# Nepal Electricity Authority

Subject: Release of Clarification

**Tender No. ICB-DCSD-2080/81-DSUEP-EIB-W6, Procurement of material, equipment, associated accessories and necessary installation services including design, erection, testing, and commissioning of 132/33 kV substation in Bajhang District - Package No. EIB-W6**

**Pre-Tender Queries and Clarifications**

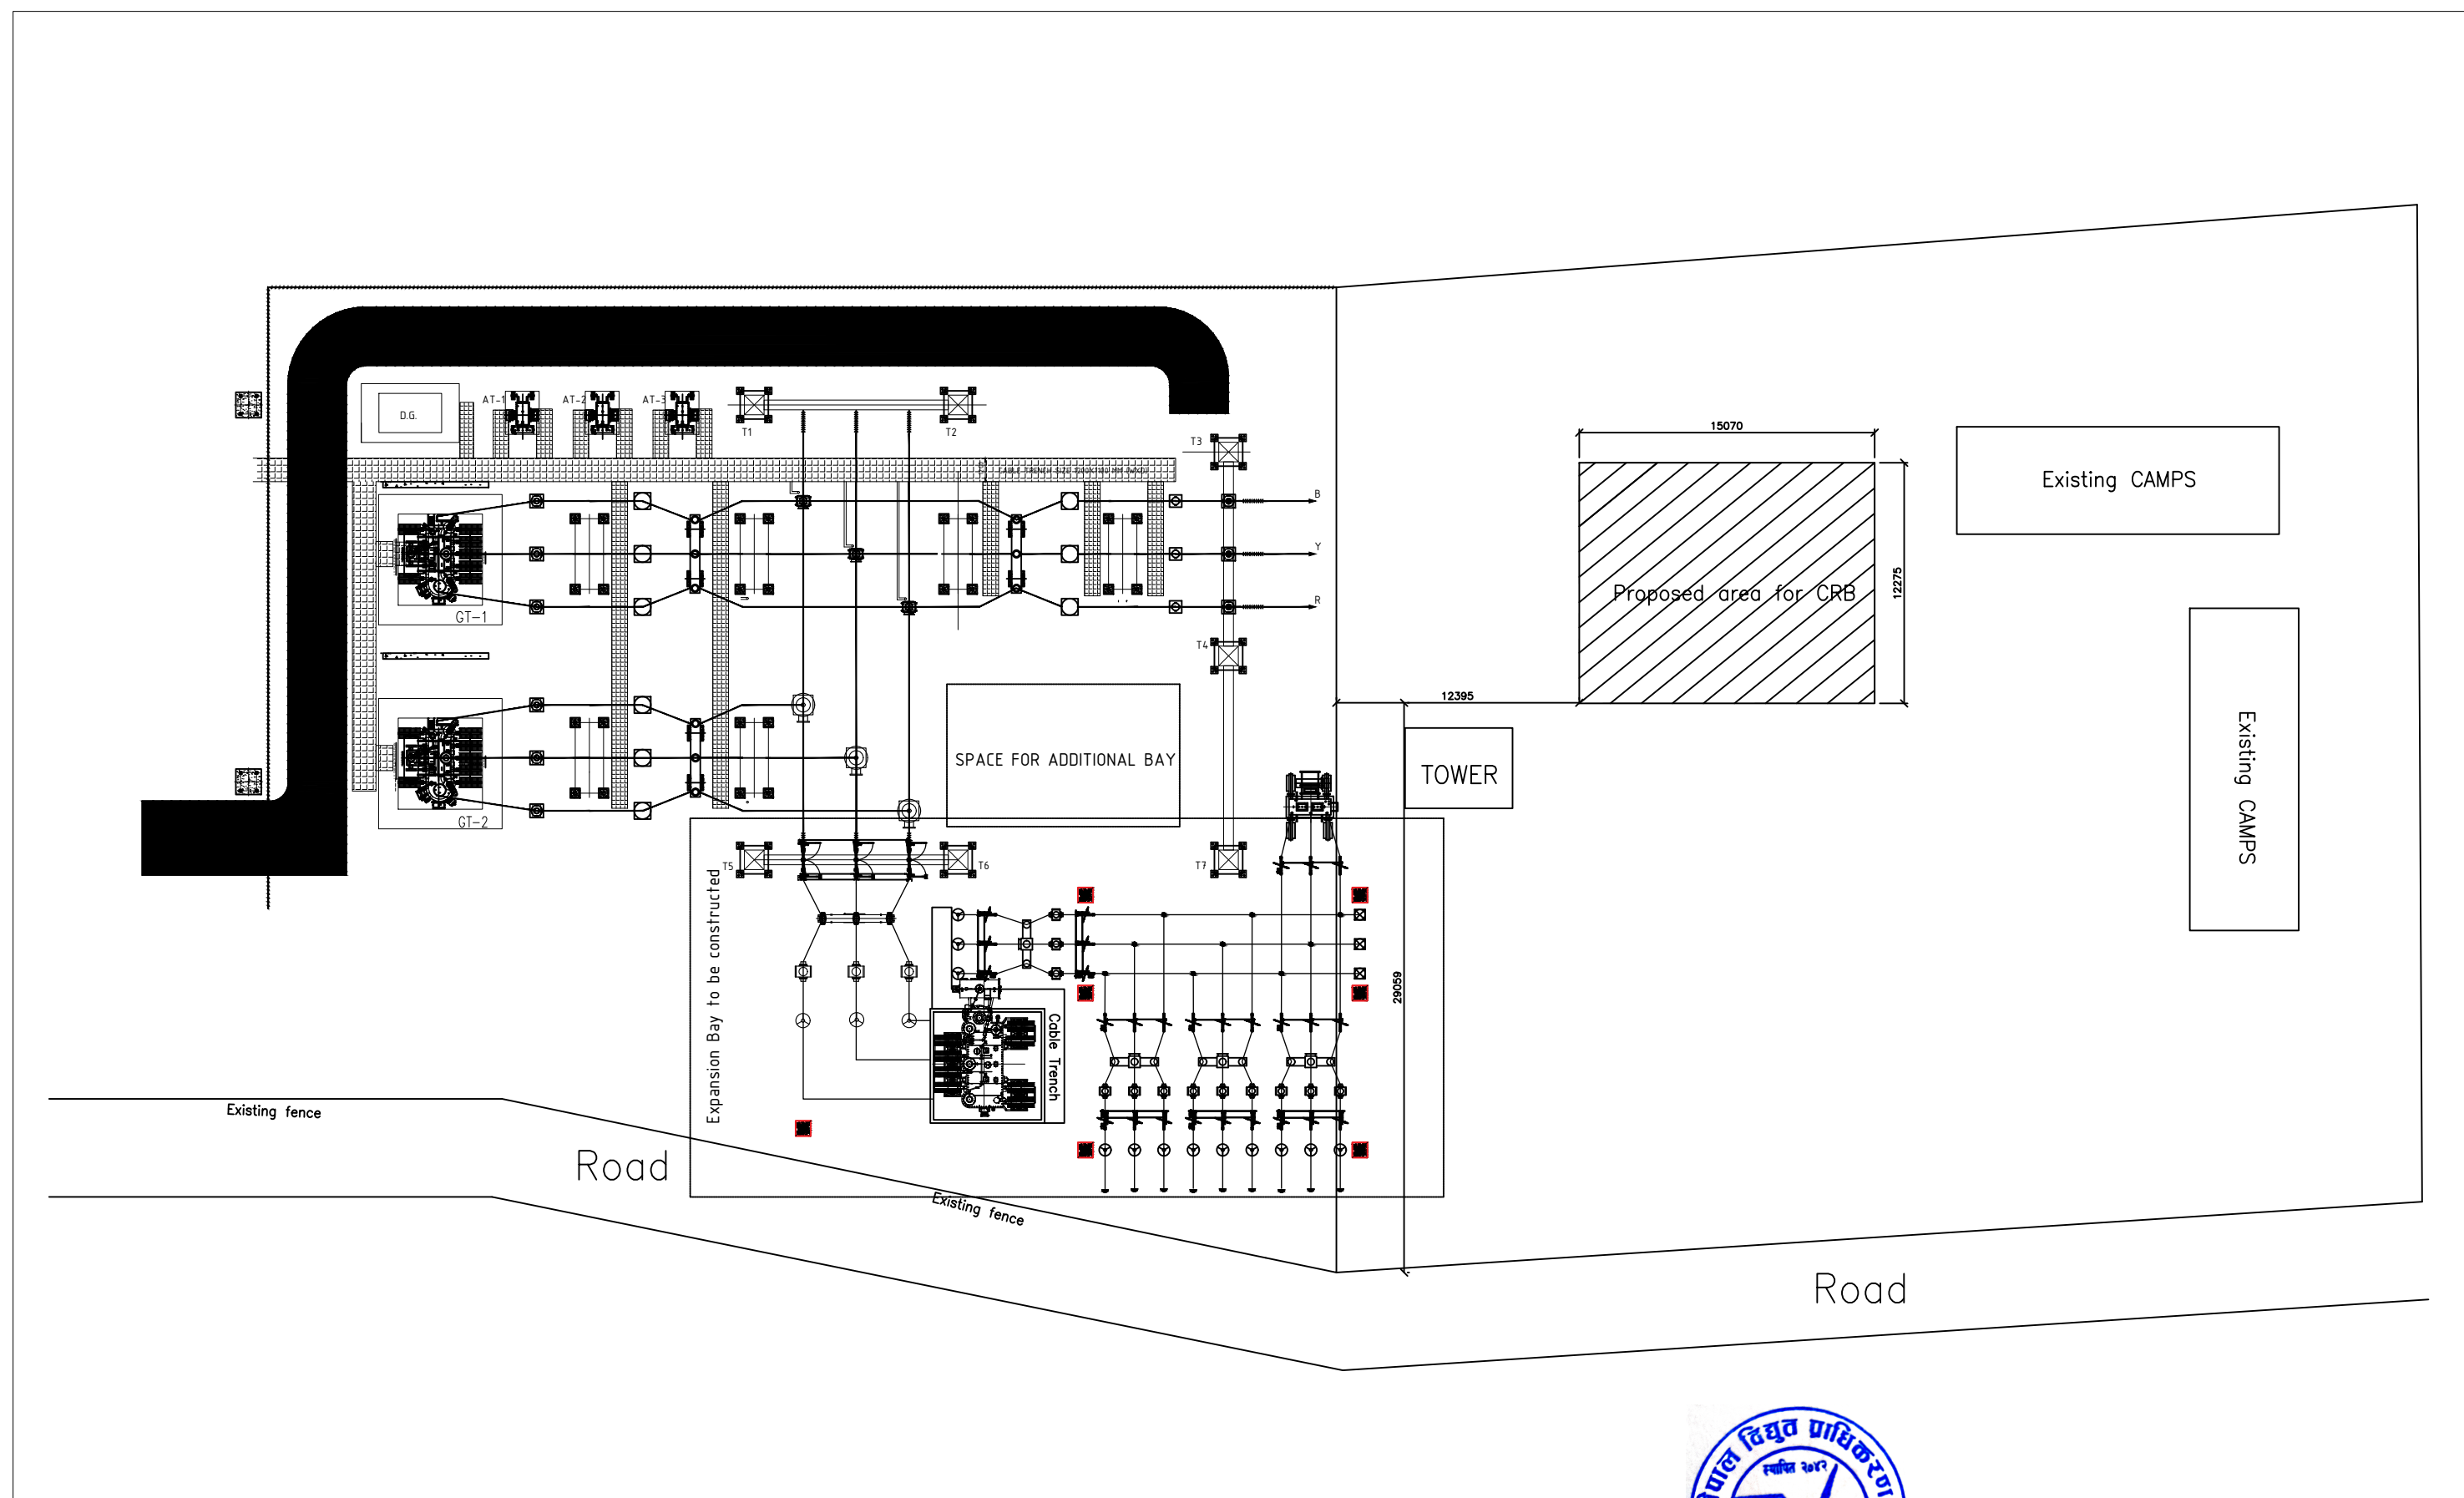
Volume / Section	Clause No. / Drawing No.	Bidder's Query	Client's Reply
	Electrical Queries			
19	Volume-2	Page no. 51 and 52, Annexure - B	Bidder request for the SLD of existing 33 / 132 kV Kalanga Substation and indicative SLD of this extension project .	It is attached with this Clarification.
20	Volume-2	Page no. 51 and 52, Annexure - B	Bidder request for the clarification of scope area through marking in the attached layout drawing of existing 33 / 132 kV Kalanga substation.	The area is within the premises of the Kalanga Hydropower Station and area will be finalized after site survey. Please refer to the attachment.
21	Volume-2	Page no. 51 and 52, Annexure - B	Bidder request for the clarification in layout drawing, about connection between 132 kv transformer bay with existing 132 kV busbar of existing 11 / 132 kV Kalanga substation.	We expect the Contractors to propose the design appropriately as per TS and BOQ.
